# General Service Bulletin

## CVHE-F with Rockwell LF 2.0 Drive

ORDER No.: CTV-SVB04A-EN

### **Inductor mounting inspection and adjustment (Refrigerant Cooled Only)**

**Figure 1. Top view of LF**

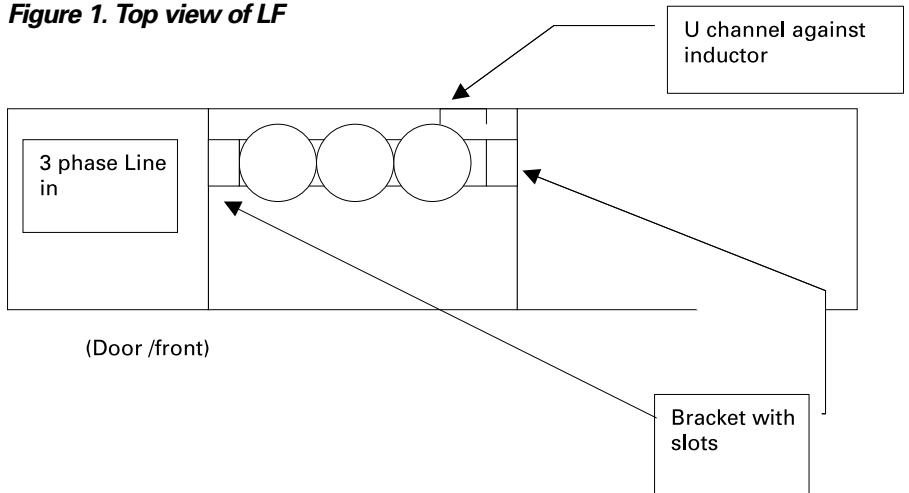
The problem area can be inspected by opening the left hand front door and reaching in at the top to feel for the clearance between the rightmost upper winding and the cabinet frame. See figure 1. Rockwell has changed the assembly and are now providing approximately 1/2 inch of clearance.

**Figure 2. Illustration with no clearance. View is from rear of drive. Back cover removed.**

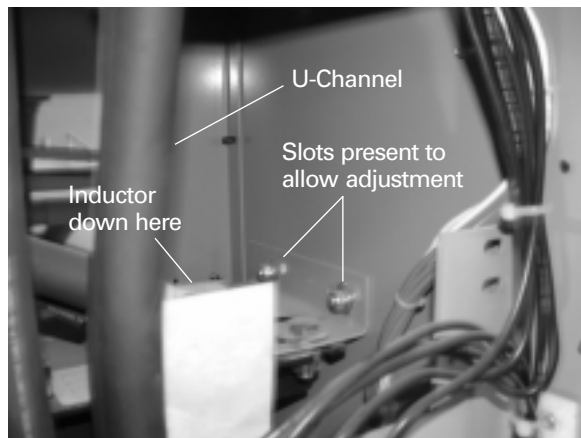
Figure 2 is a picture of the inductor in a new LF2.0 608amp Rockwell drive. This picture illustrates an inductor too close to the u channel.

- In the field we would like an 1/2 inch if possible, however the existing slots and adjustments will likely not provide an 1/2 inch in all cases.

- There is insulation paper between all inductor conductors and the U channel. The absolute minimum is 3/16 inch.

It is desired to have 3/16" (4.75mm) to 1/2" (12.7mm) between the inductor and the u-channel. Refer to Figure 2.
